Ref: 17-000934.3015TM02.AM.rl

Subject: AURA Precinct 11 to 14 – Additional Engineering Information

This Technical Memorandum is to provide additional information following the EDQ Engineering Comments dated October 2020 and subsequent layout change.

DRAWING TITLE	PROJECT No.	DRAWING No.	REVISION
SWEPT PATH MOVEMENTS	17-000934	3015-SK2010	-

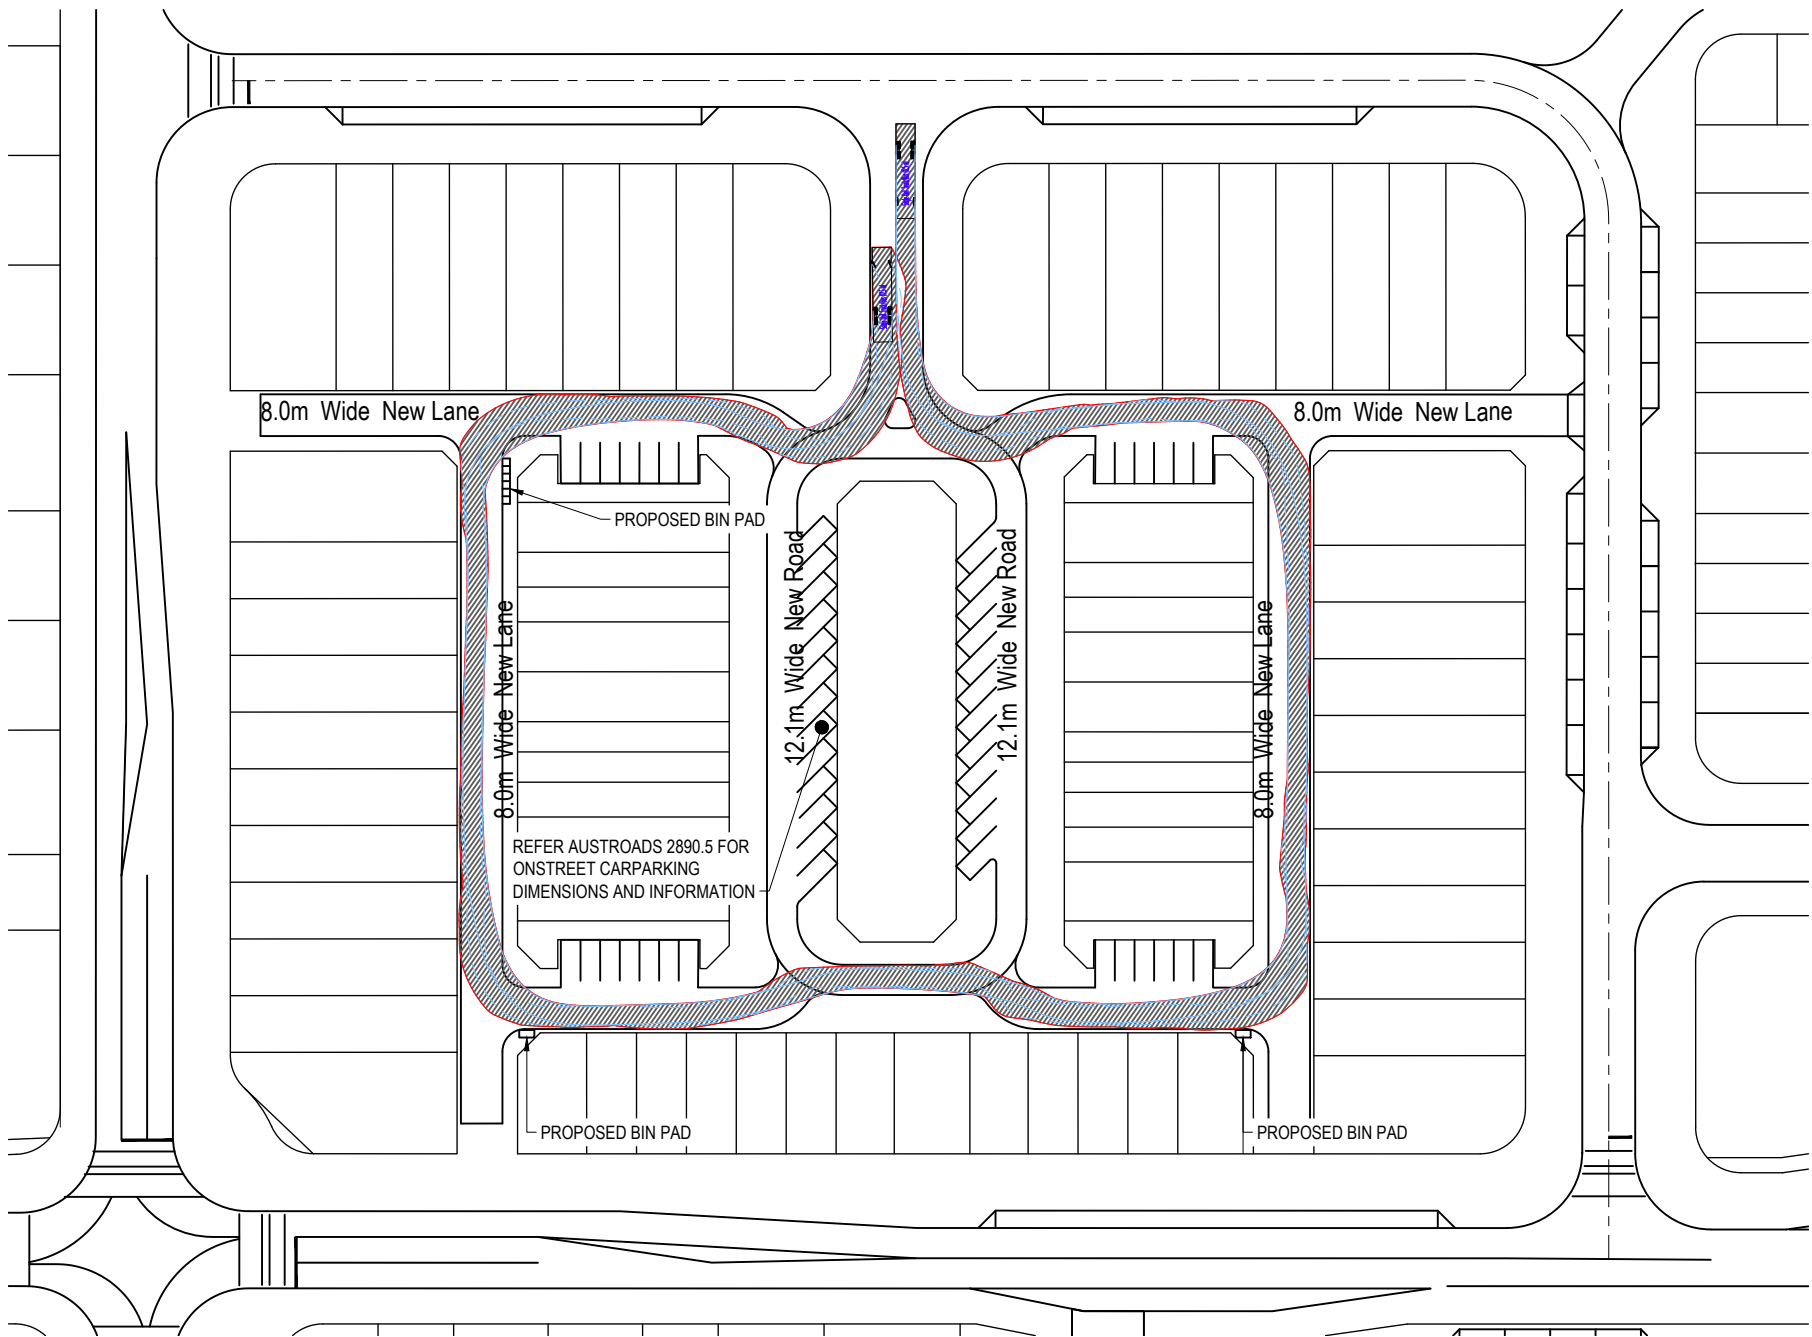
ROL Sheet 02 Item 1.

The former "innovation precinct" is now a precinct of terrace homes. EDQ does not support the laneways coming out onto the external Trunk Connector roads to the west and south. This precinct should be redesigned so that access to the laneways is gained from the adjacent Neighbourhood Connector Roads. Swept paths for an RCV are to be provided so as to demonstrate that appropriate access is available through the terrace precinct for the design vehicle.

ROL Sheet 02 Item 10.

Alignment of intersection of laneway entrance and 17.5m road in Stage 1133 needs to be reviewed

Following the EDQ Engineering Comments the layout in this precinct has been revised. There are no longer laneway connections to the west or south.

Calibre has prepared swept path movement sketches indicating trafficability in this area suitable for an RCV. The sketch plan **17-000934.3015-SK2010** demonstrates:

- The laneway reserve (minimum width 8m) configuration and 5.5m carriageway width are sufficient to enable direct frontage refuse collection for each lot,
- A 12.5m refuse collection vehicle can negotiate the laneway network in the forward gear,
- widening of the laneway carriageway maybe be required at some significant bends in the rear access lanes, subject to detailed design.
- Some vehicular crossovers from adjacent road network may need to be widened, subject to detailed design.
- Bin Pads are located near lots where refuse collection is restricted.

A layout change has been undertaken and the laneway has been removed near the intersection between the Neighbourhood Connector Street and Access Street. Calibre Sketch plan **17-000934.3015-SK2010** indicates the updated layout.

DRAWING TITLE
**LANEWAY CONNECTION
STAGE 1143**

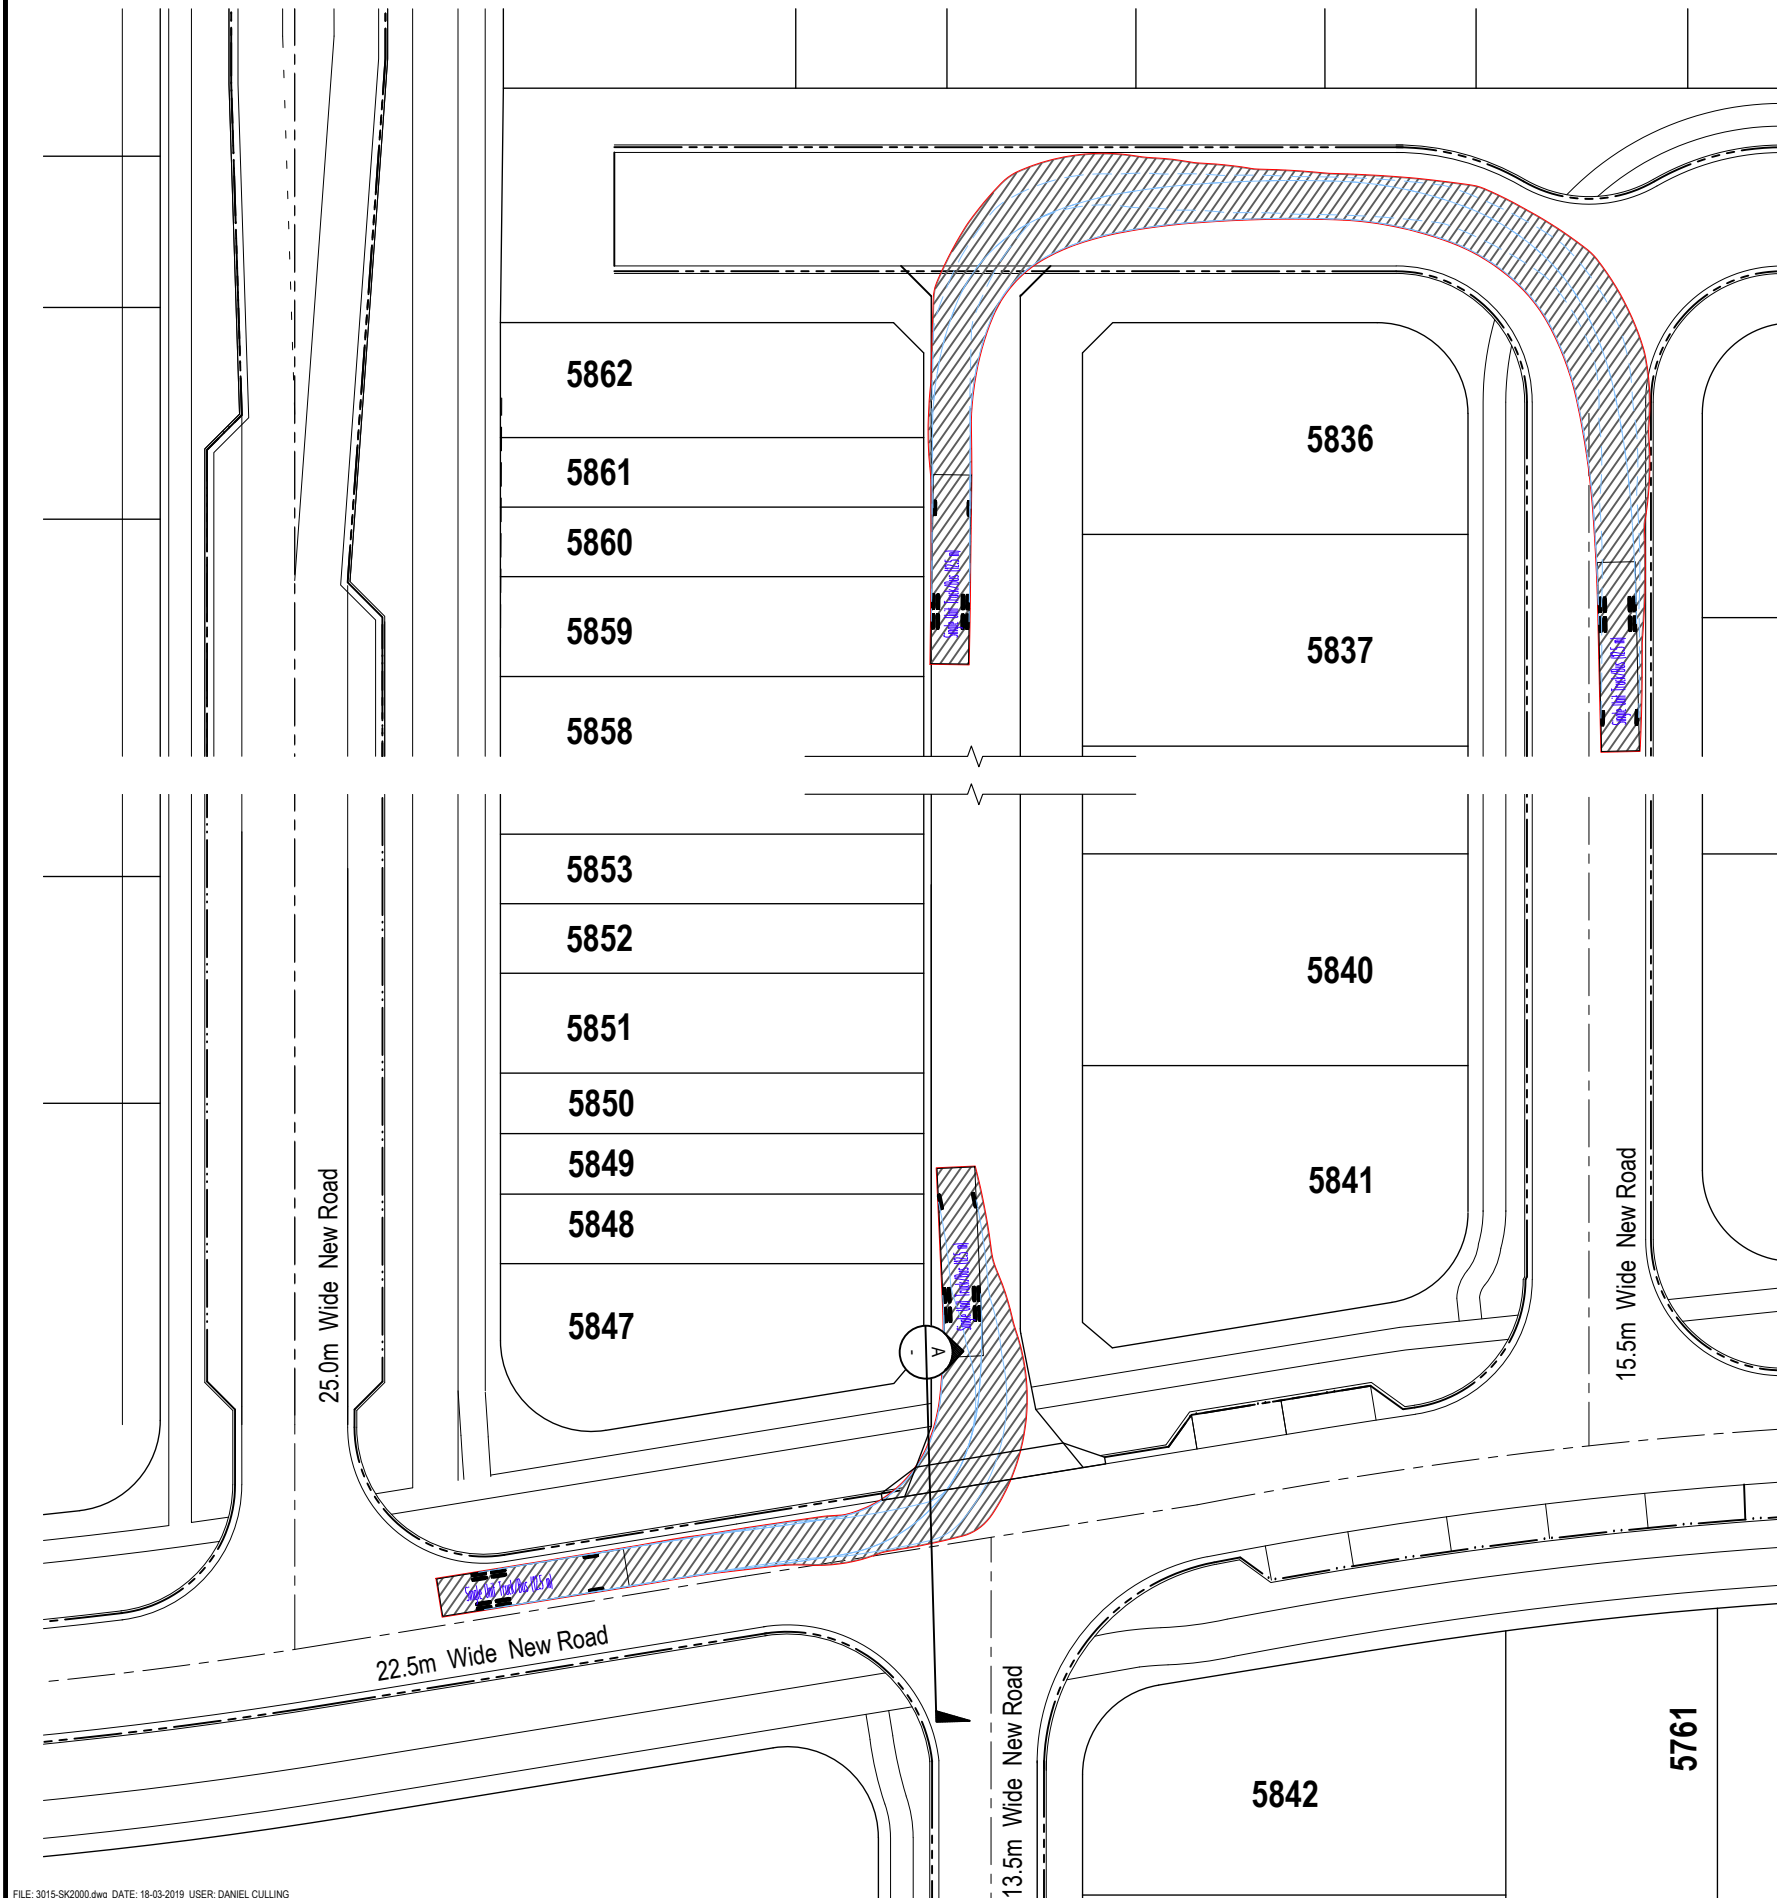
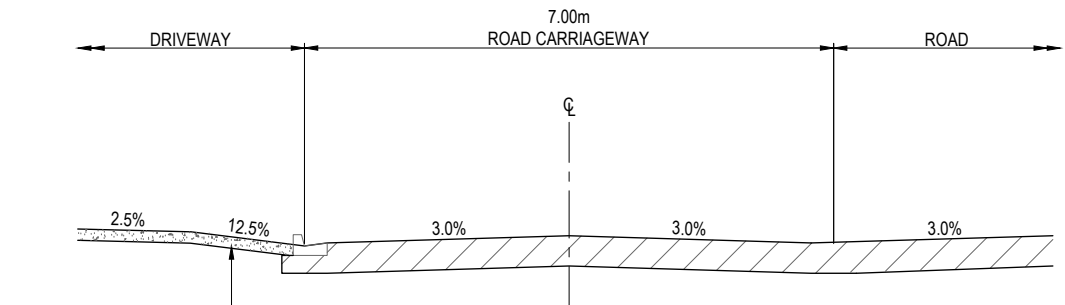
ROL Sheet 04 Item 1.

Stage 1447 features a number of 4 way intersections between laneways and streets that are considered undesirable. A traffic engineer needs to provide a statement of compliance with accepted current road design standards

Calibre Sketch plan **17-000934.3015-SK2012** provides details on another so called “4 way intersections” between laneway and streets in Stage 1443. This Laneway entrance is designed to demonstrate:

- Delineation of the higher order road with continuation of the kerb alignment and vehicle crossing
- Delineation of the higher order road with different surfacing texture and colour
- The cross section indicates the changes in elevation
- Good sight distances with no parking bays immediately adjacent
- Refuge Collection Vehicle can enter via left hand turn without entering other traffic lanes.
- The Laneway entrance, or fourth leg of the intersection, is more like a driveway than an additional road in the intersection
- As such there is great clarity for pedestrian and vehicular traffic regarding the higher order roadway and priorities between turning movements.

The laneway is estimated to have a traffic volume of about 150 vehicles per day connects to a road with traffic volume of has less than 1000 vehicles per day. For a Neighbourhood Lane EDQ PDA Guideline No. 06 indicates a maximum 500 vehicles per day. This laneway has significantly lower traffic volume.

SWEPT PATH MOVEMENTS
STAGE 1430

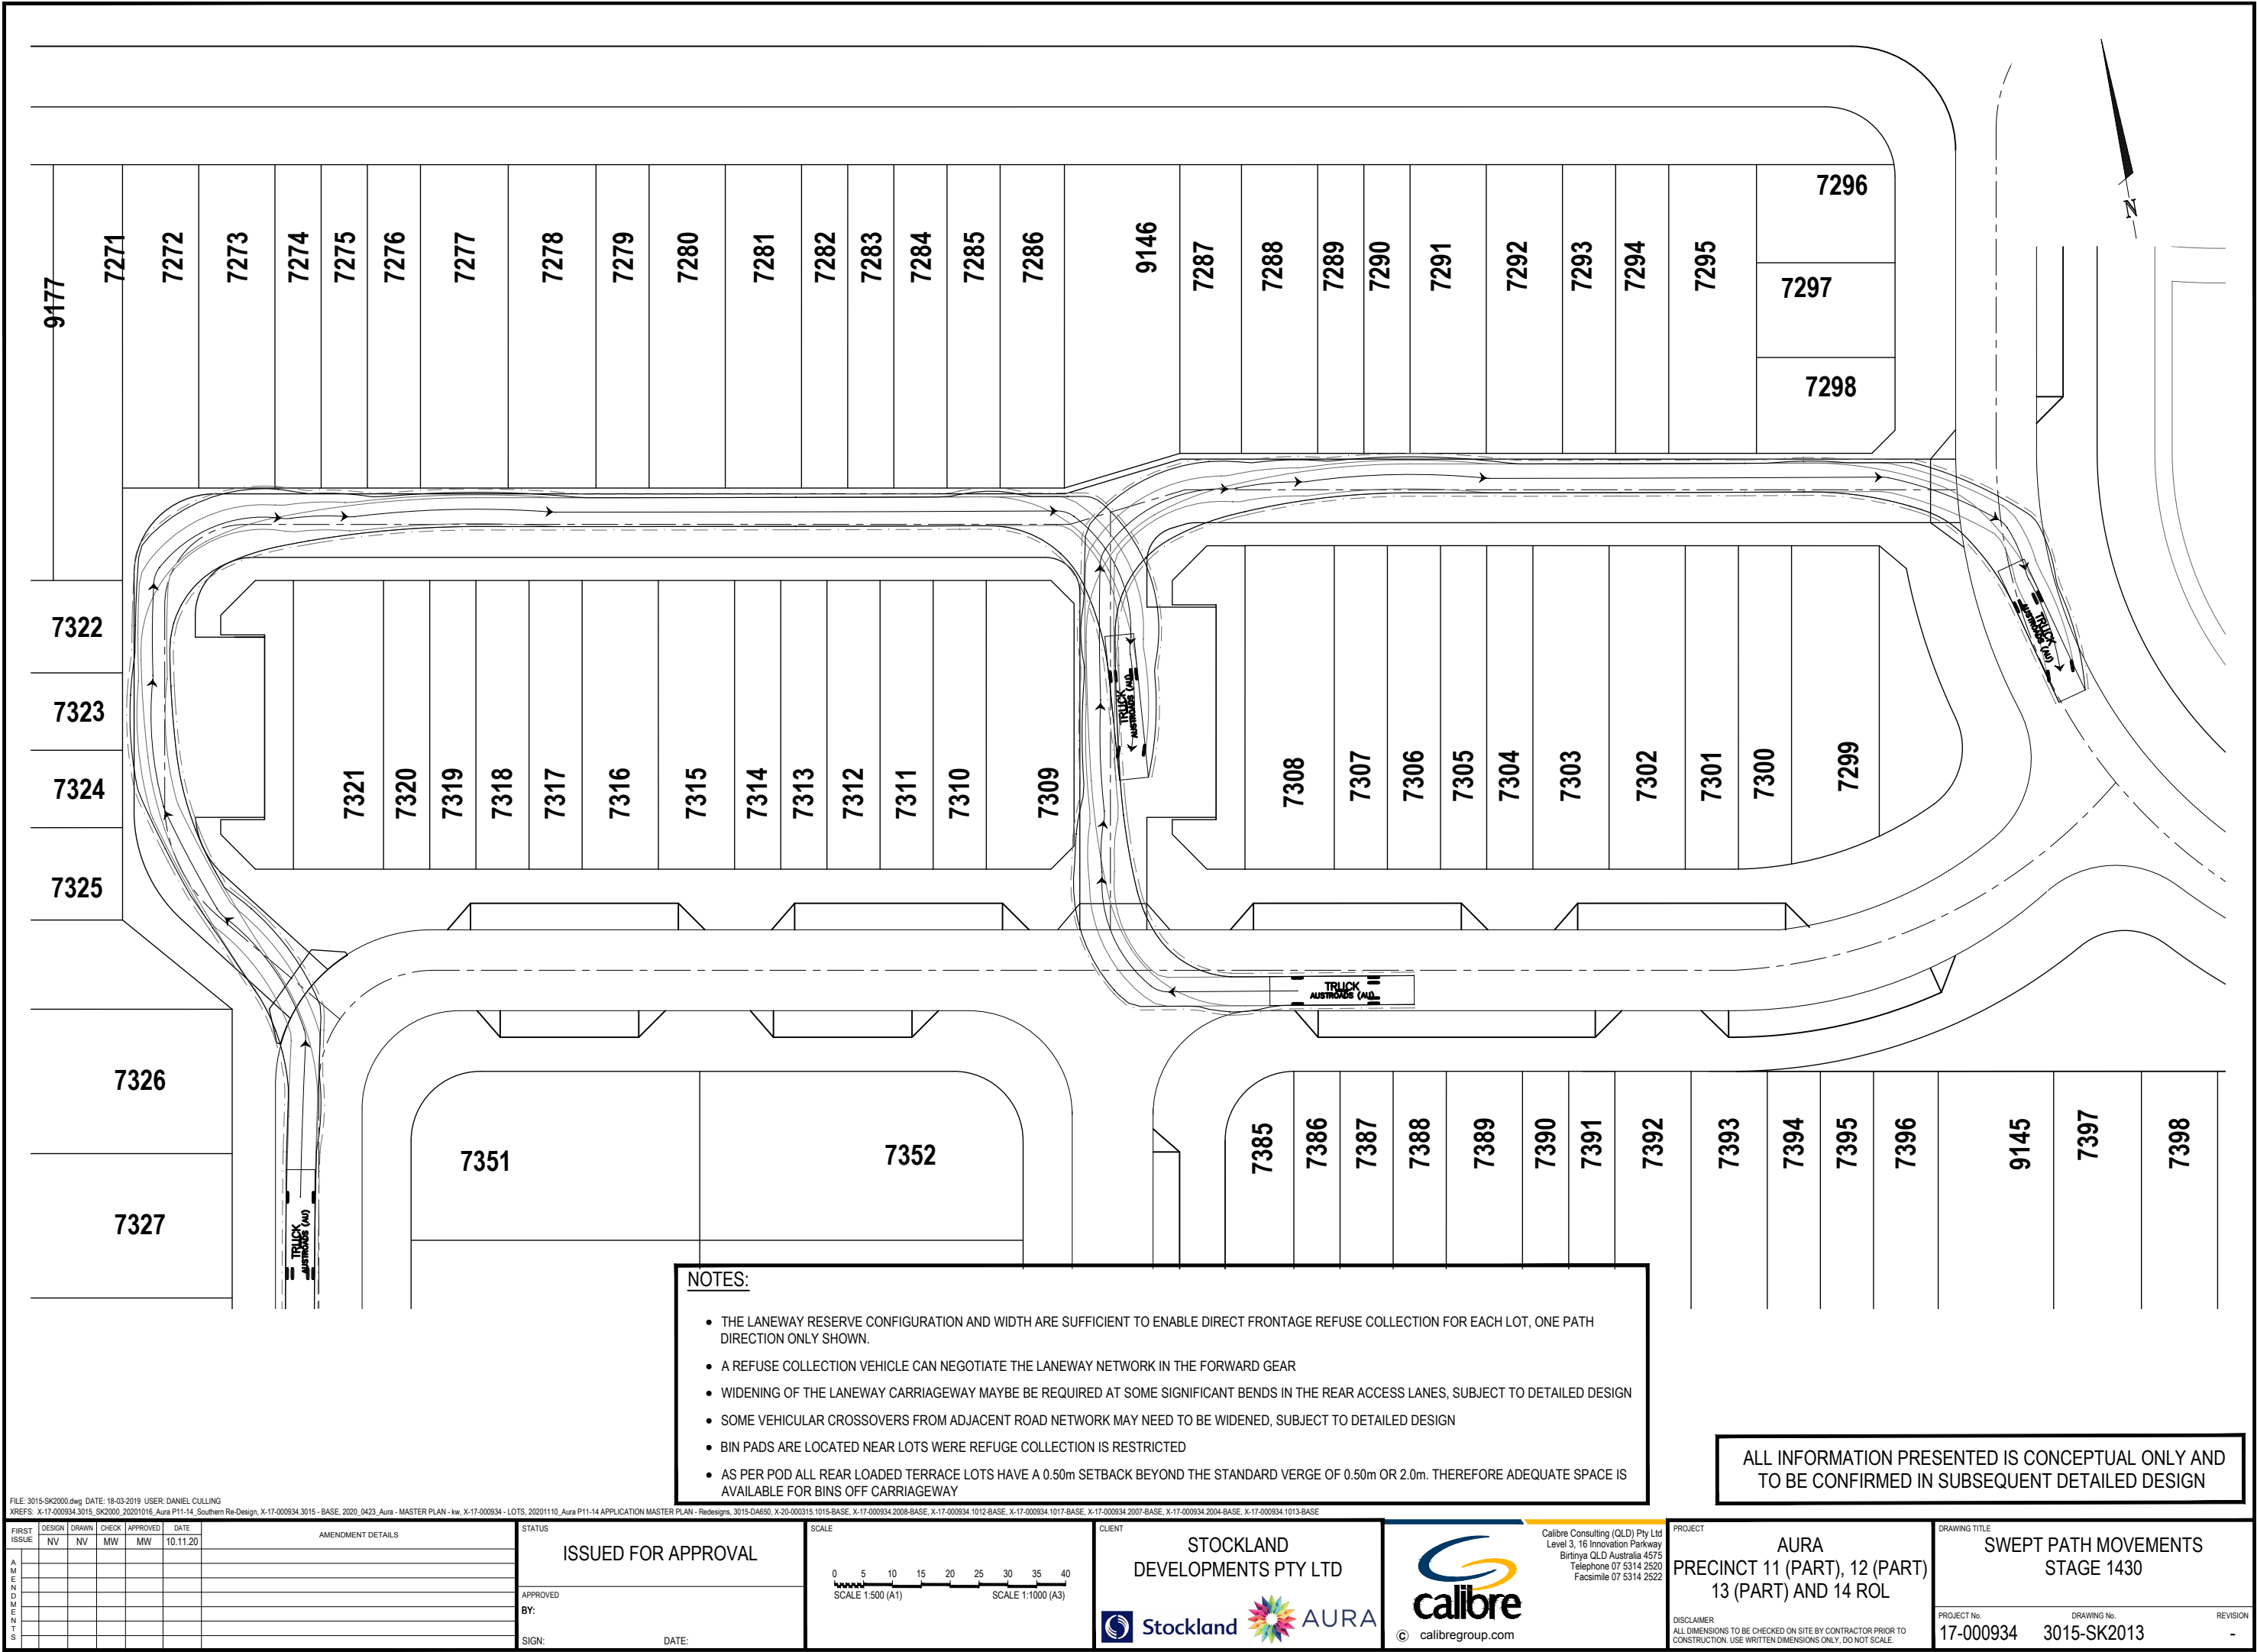
ROL Sheet 06 Item 1.

Laneways in Stages 1430 and 1431 feature 90 degree turns and other various horizontal geometry (as do many other terrace product precincts throughout the other Stages). Swept paths for an RCV for all laneways should be provided to demonstrate manoeuvrability for the design vehicle (RCV) to all terrace housing precincts

For Stage 1431 we have not prepared the swept path movements but have prepared Sketch Plan **17-000934.3015-SK2013** for Stage 1430 as this lane way route has tighter bends and considered more critical.

This demonstrates manoeuvrability can be provided in these laneways.
